SI_SPLS_002
Revision 02

SERVICE INSTRUCTION

SI_SPLS_002

FUEL SENSOR UNIT REPLACEMENT

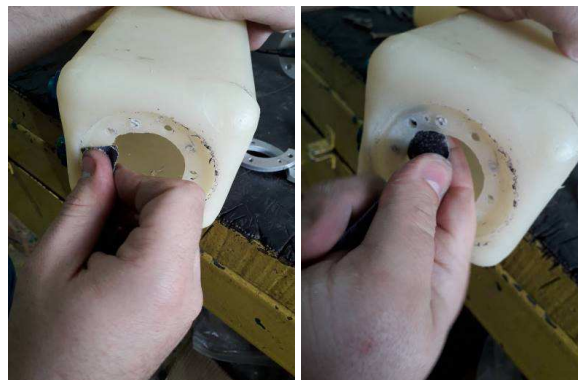
7. Remove the fuel sensor.

8. Clean the PRC from the header tank top surface.

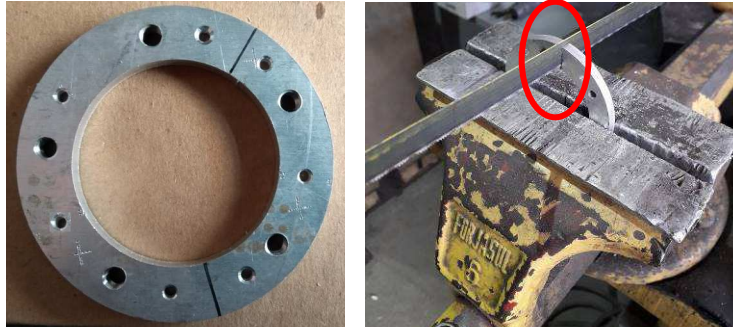
9. Install the support plate on the header tank. Drill the top surface with 3/32 inches in order to install the rivets.

**NOTE**

Rivets countersunk holes should face down to accommodate rivets expansion.

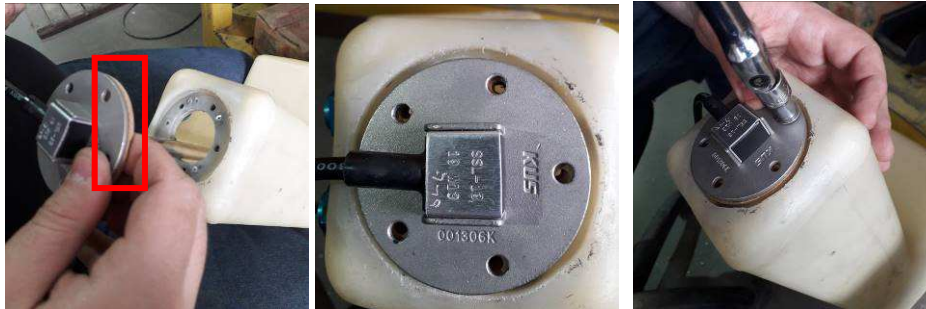
12. Install the halves of the support plate in the internal part of the header tank top using the fixation bolts. Then install the rivets.

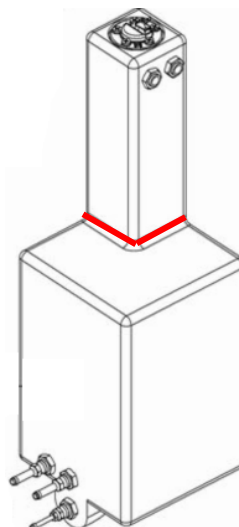
15. Install the fuel sensor with the cork gasket. Apply Loctite 577 on the bolts and torque with 35 lbf.in. / 4 N.m.

There is a single position; the holes of the fuel sensor will match with the holes of the header tank.
